# Technical Note

<b>Project</b>	Plots 23-26, The Oxford Science Park	<b>Project No</b>	13886
<b>Subject</b>	Section 73-Undercroft Amendments	<b>Date</b>	6 December 2023
<b>File Ref</b>	13886-CRH-ZZ-XX-TN-C-0004-P1_TN-Undercroft Removal.docx	<b>Pages</b>	10

This Technical Note has been prepared in support of a Section 73 amendment application and discharge of condition application to Plots 23-26 of Oxford Science Park to discuss changes made to the undercroft across the proposed development and the impact this change has on both the proposed site surface water drainage strategy and flood risk. The original planning application was submitted to Oxford City Council in September 2022 ref. 22/02168/FUL

**RPZ Overlaid on Drainage Layout  
Sheet 2 of 2**

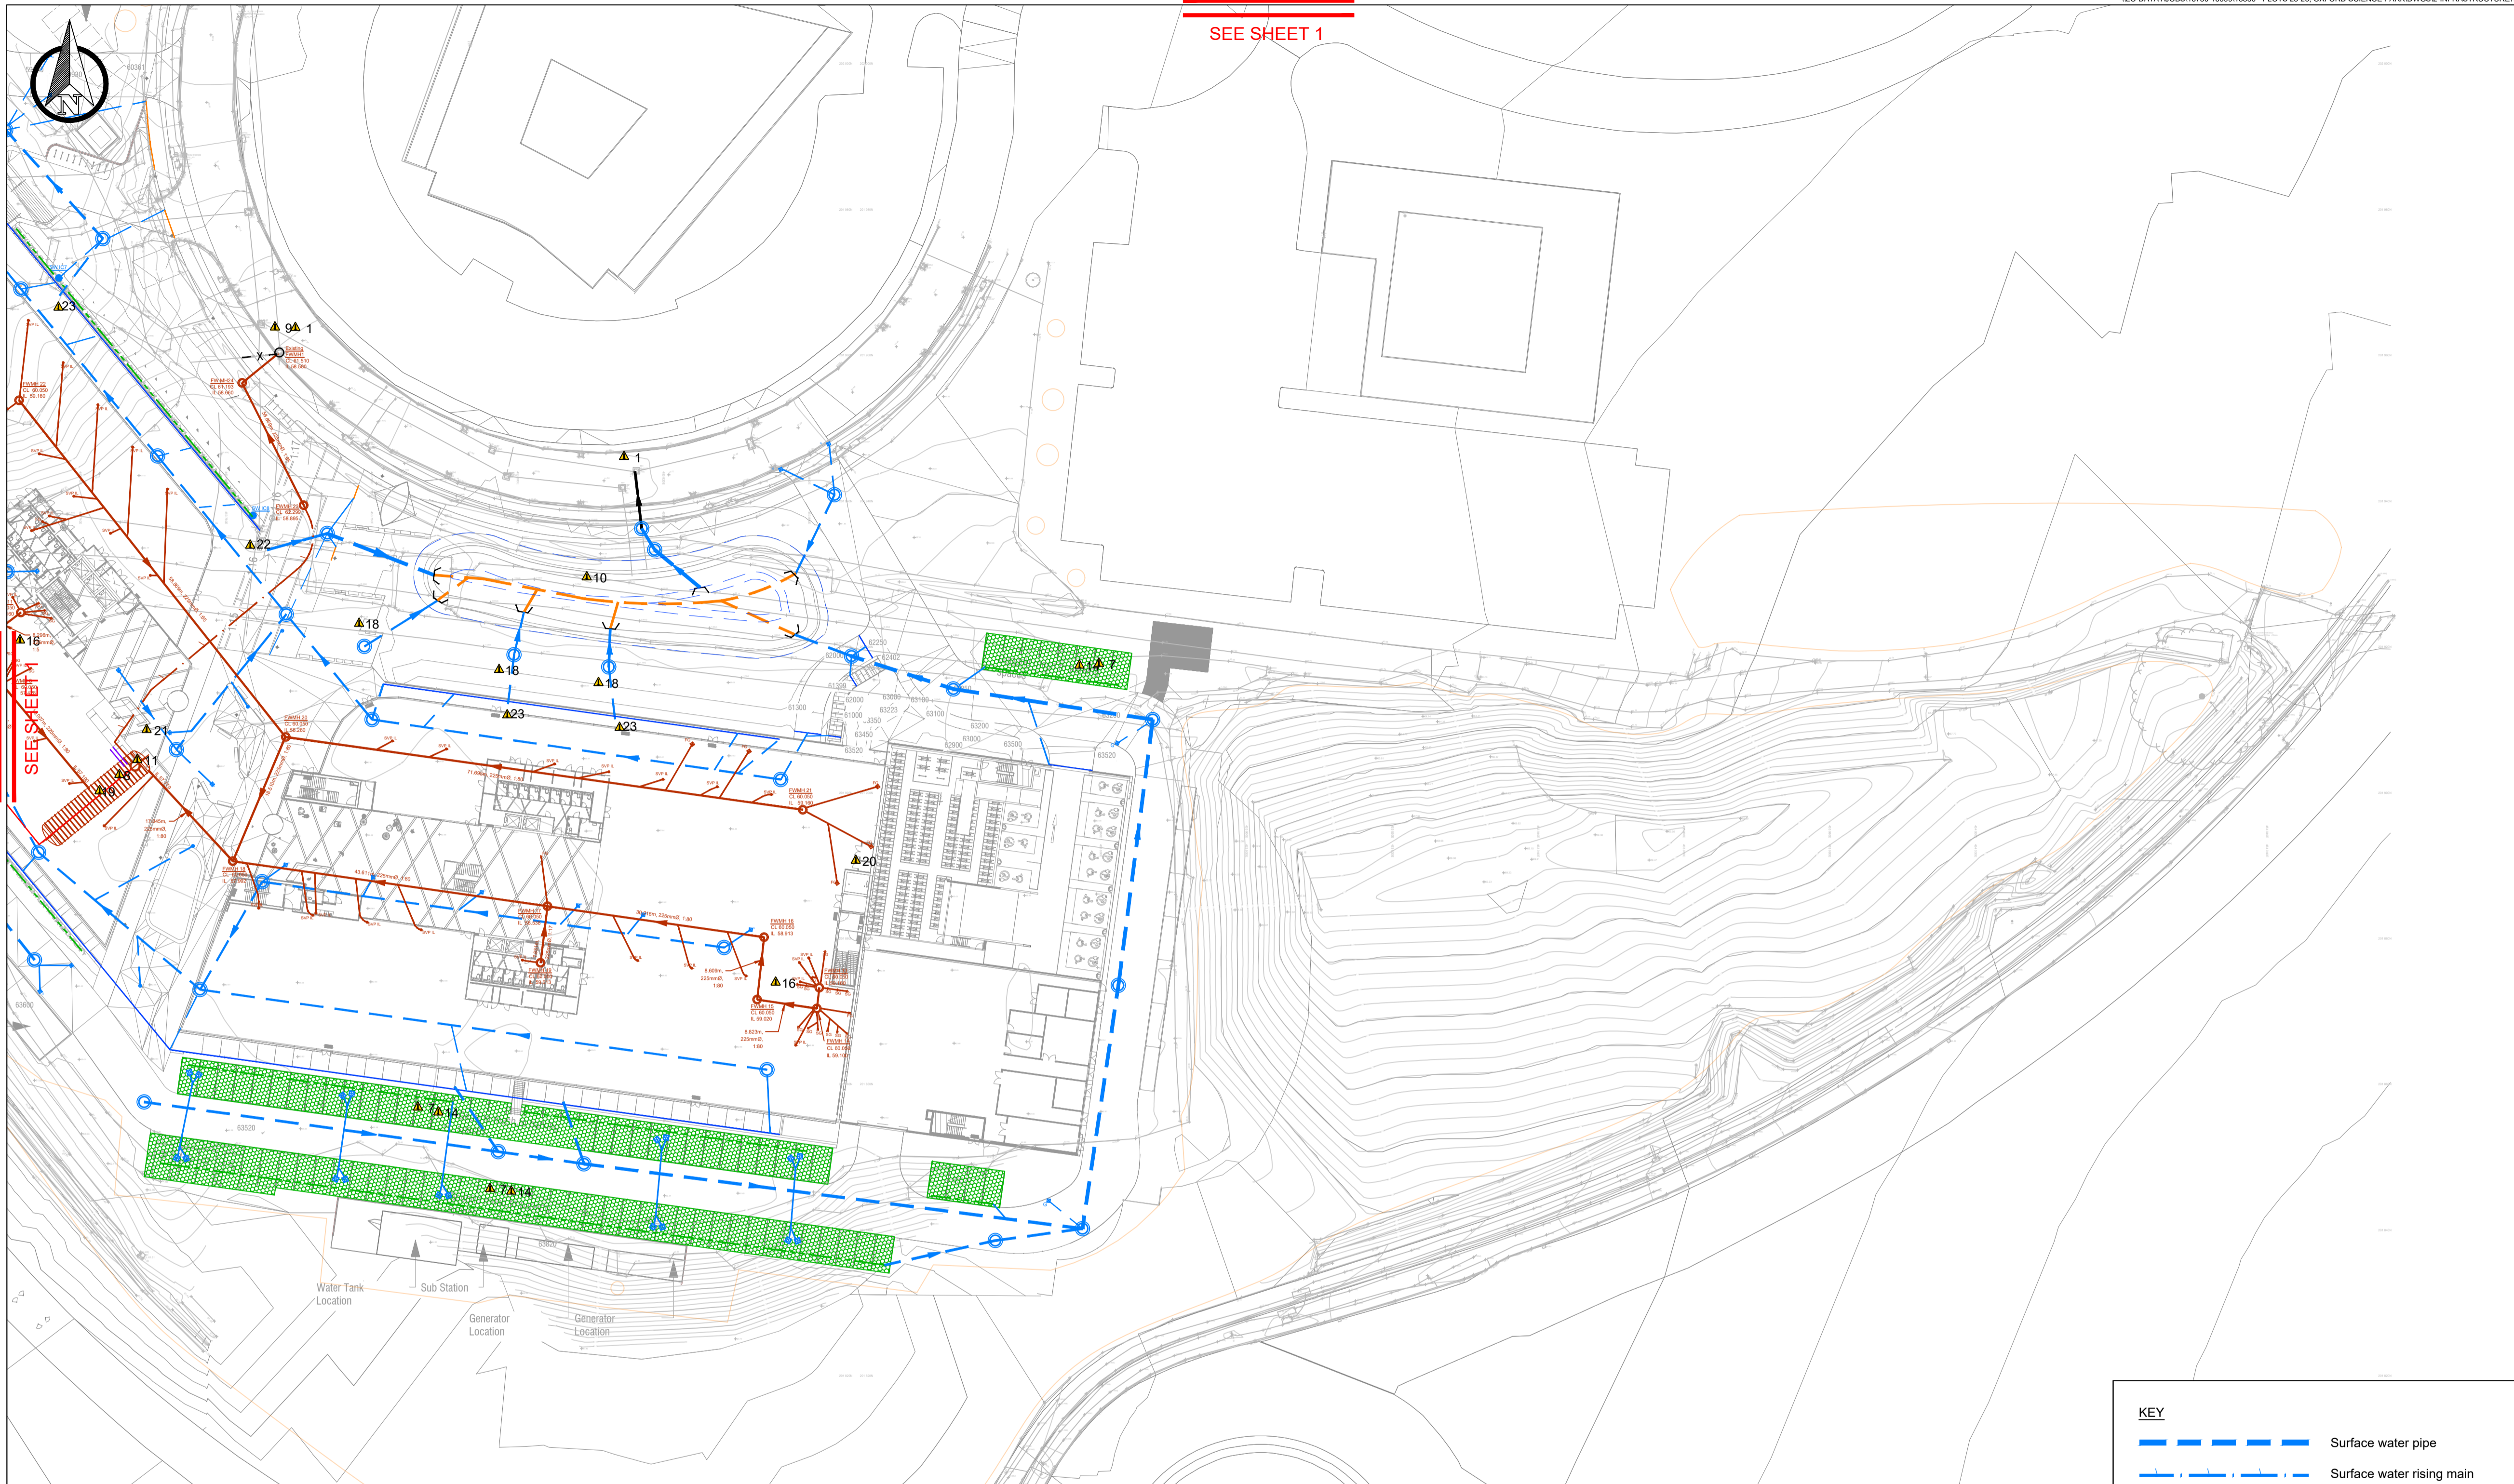
- 13886-CRH-ZZ-XX-DR-C-5057-P1-Proposed Drainage Strategy
- 13886-CRH-ZZ-XX-DR-C-5058-P1-Proposed Drainage Strategy
- 13886-CRH-ZZ-XX-DR-C-5059-P1-Proposed Drainage Strategy
- 13886-CRH-ZZ-XX-DR-C-5060-P1-Proposed Drainage Strategy
- 13886-CRH-ZZ-XX-DR-C-5400\_P2 RPZ Overlaid on Drainage Layout (Sheet 1 of 2)
- 13886-CRH-ZZ-XX-DR-C-5401\_P2 RPZ Overlaid on Drainage Layout (Sheet 2 of 2)

P1	Drainage Updated	05/12/23	ZA
P1	Issued for information	22/02/23	IC
Rev	Description	Date	By
